STAFF REPORT: 9/13/2023 REGULAR MEETING PREPARED BY: J. ROSS

ADDRESS: 1405 CHICAGO BOULEVARD

APPLICATION NO: 2023-8519

SCOPE: REPLACE WINDOWS, FENCE, LANDSCAPING (WORK COMPLETED WITHOUT APPROVAL)

1405 Chicago Blvd., current appearance. Staff photos taken on 8/31/2023

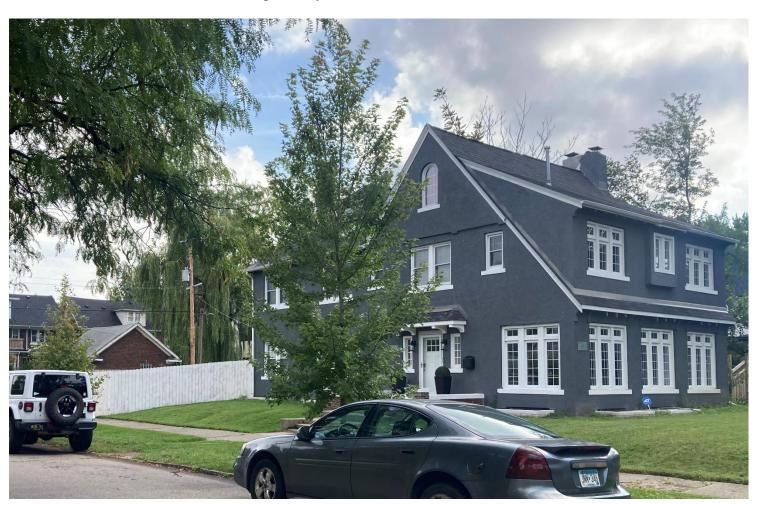
The property at 1405 Chicago Boulevard. is a two-story, single-family home that was erected ca. 1920. Although the property has a Chicago Boulevard address, the front façade faces east on Byron Street. The building features a front-gabled main mass with an intersecting hipped roof wing at the south side. A full-width, shed roof dormer and smaller hipped-roof dormers top the roof. Exterior walls are clad with stucco which has been painted grey. Windows are double-hung, casement, and fixed vinyl units which were installed without Historic District Commission approval. A 6'-0" tall wood fence encloses the building's side yard.
